**The 14th Meeting of the Department of Computer Science and Technology
Buildings and Environment Committee**

**Extraordinary Meeting
of the Department of Computer Science and Technology
Buildings and Environment Committee**

2. Library Refit

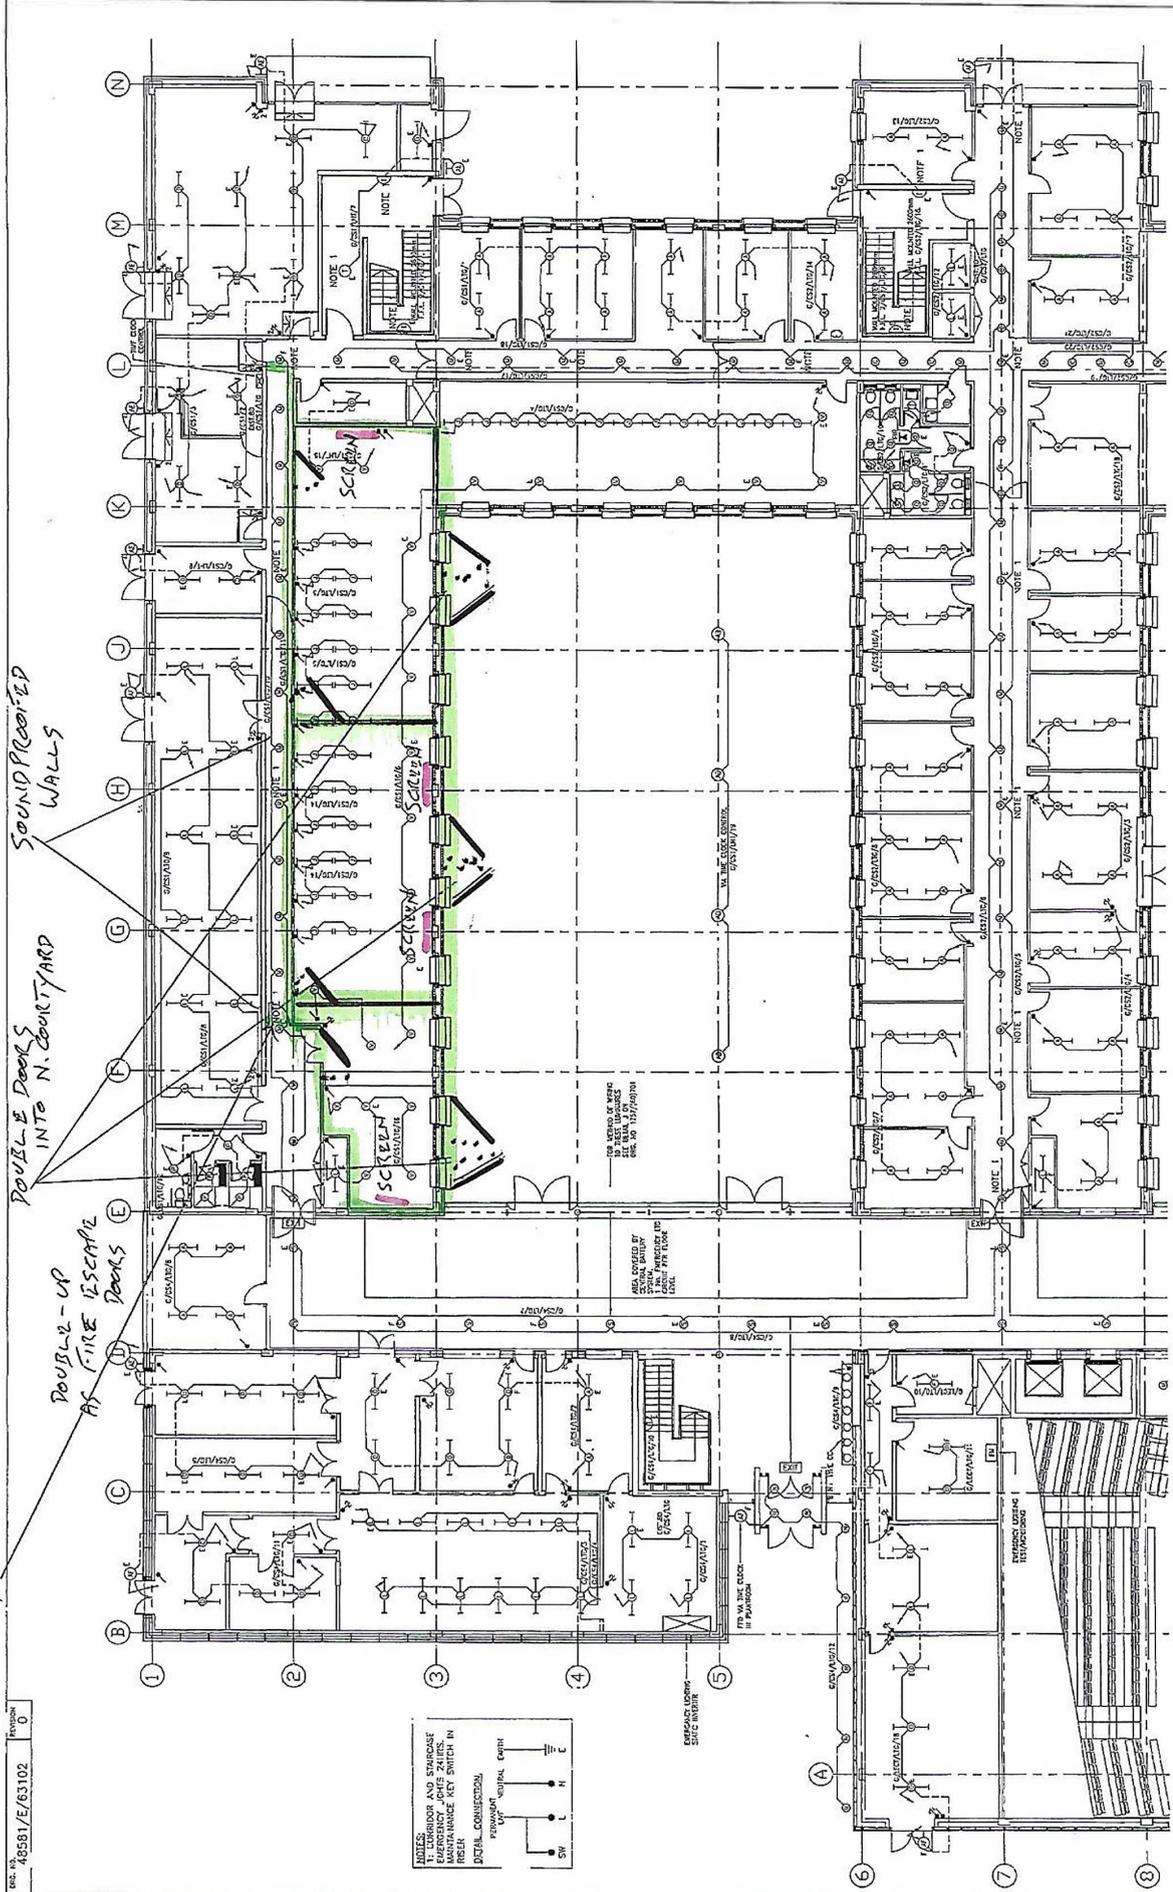
INCREASED AIR FLOW
 LARGE SCREENS - NOT OVERHEADS
 ADJUSTABLE LICHTING

KEEP EXISTING
 SECURITY DOOR

DOUBLE DOORS
 INTO N. COURTYARD

DOUBLE-UP
 AS FIRE ESCAPE
 DOORS

SOUND PROOFED
 WALLS

AREA COVERED BY
 SOUND PROOFING
 TO BE CONSIDERED
 AS PART OF THE
 SOUND PROOFING
 WORKS TO BE UNDERTAKEN
 IN ACCORDANCE WITH
 BS 5593:2014

The Committee agreed to recommend that the space is divided into three teaching/meeting rooms, with the option to convert the middle room into two rooms later if required (for example following feedback after initial use) by way of a moveable partition wall.

Fixed dividing walls would be located as per the attached floor plan, creating three Rooms A, B and C from east to west.

Room A access would use the existing entrance.

Room B access would be achieved by creating a new door at the NW corner of the room.

Room C access would use the existing entrance at the east end of the Library.
